SIB 11 09 23

**RECALL 23V-707: REPLACE VANOS ADJUSTMENT UNIT SCREWS**This Service Information Bulletin (Revision 3) replaces SI B11 09 23 **dated February 2024**.

RE: Recall 23V-707: Replace VANOS Adjustment Unit Screw Connection – B11 09 23

#### Exhaust VANOS Adjustment Unit:

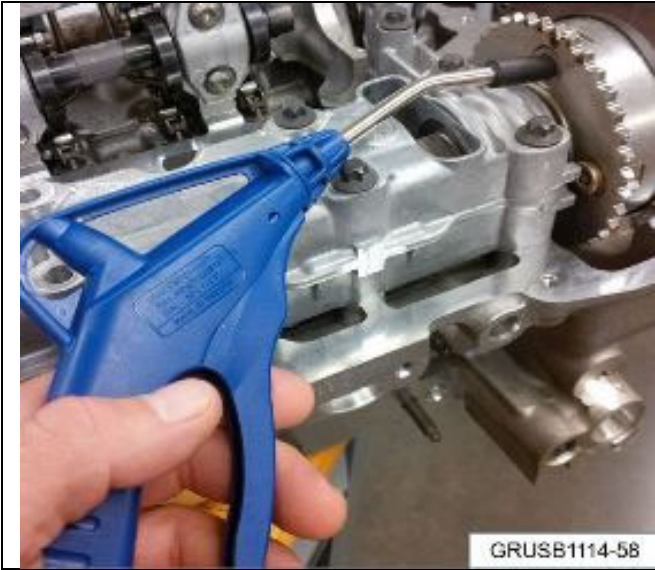
9. Replace and torque aluminum bolts (1 - 4) one at a time.

10. Turn the engine by hand using a suitable wrench on the crankshaft central bolt to align the bolt (1) with as shown in the illustration.

Remove the bolt (1) using the required special tool.

Note: The tool will be on a slight angle when loosening.

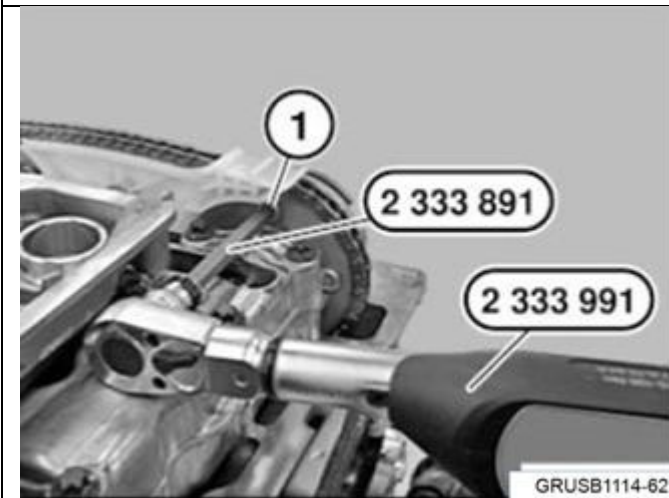
12. **IMPORTANT: The bolts require initial torque and angle torque. Observe the procedures in this step and the next step very carefully!**

Install one new P/N 11 36 8 602 263 aluminum VANOS bolt and apply the initial torque using the required special tools to the specification below.

**Initial torque: 6 Nm**

**Angle torque: 60°**
